MEMORANDUM

TO: District of Columbia Board of Zoning Adjustment
FROM: Stephen Gyor AICP, Case Manager
 JL Joel Lawson, Associate Director Development Review
DATE: May 5, 2015

SUBJECT: BZA Case 18997 - request for special exception relief under § 223 to allow the construction of a two-story rear addition with accessory apartment connected to the dwelling by a covered walkway at 148 11th Street SE.

1
C4 VIEW OF REAR

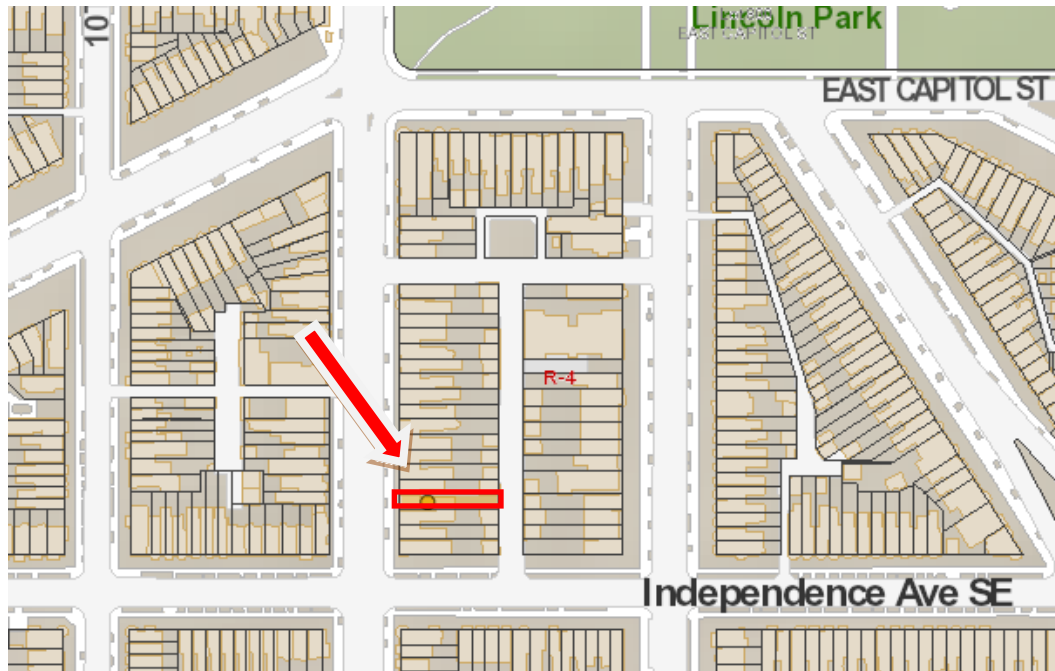
In response to neighbor requests, the Applicant submitted to the ANC a proposal with a revised building height of 20 feet, a double window facing the rear yard shifted to the south (away from the neighboring property at 146 11th Street SE), and the sill height raised for the smaller window. As of this writing, this revised proposal has not been submitted to the record.

The Applicant's proposal, dated April 9, 2015 (Exhibit 25), includes a reduction in the height of the structure from 22 feet to 20 feet. The height reduction should result in a structure more in scale with neighboring accessory structures and allow for more light and air to neighboring properties.

The proposed structure would have no windows or other openings on the sides and would be constructed between and adjacent to two other accessory garages. Nevertheless, the proposed structure's windows would allow views into the neighboring rear yards. Further, the rear façade of the neighboring property to the north, 146 11th Street SE, was built in a modern vernacular and is largely comprised of glass. The proposed addition would allow a view of that property's rear façade.

The Office of Planning would support additional modifications to the proposed windows, including the use of a single instead of double window on the structure's yard-facing façade.
